DART Silver Line Regional Rail Project Community Meeting Summaries City of Dallas

Summary for Silver Line Community Meeting – City of Dallas

Thursday, August 4, 2022, at 6:30 p.m.

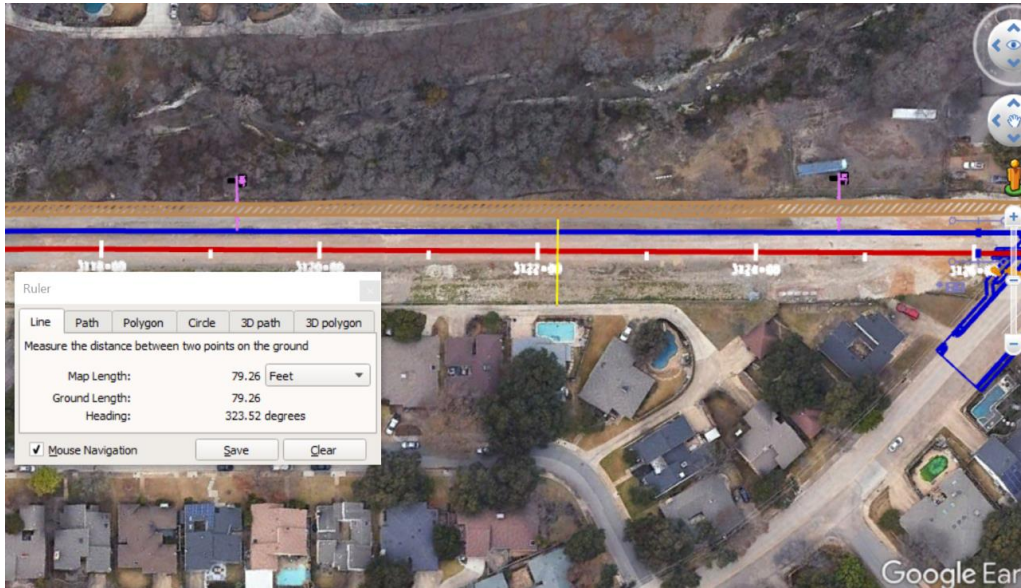
How many cars per morning rush hour are you calculating will exit University Place and how many cycles of traffic lights will it take to get out of the subdivision?

Please contact Ghassan (Gus) Khankarli, Director of Transportation with the City of Dallas at Ghassan.Khankarli@dallascityhall.com or 214-671-9957 to obtain any specific information on traffic counts or projections the city may have as this was not an area included in DART's traffic analysis required by the FEIS (Final Environmental Impact Statement).
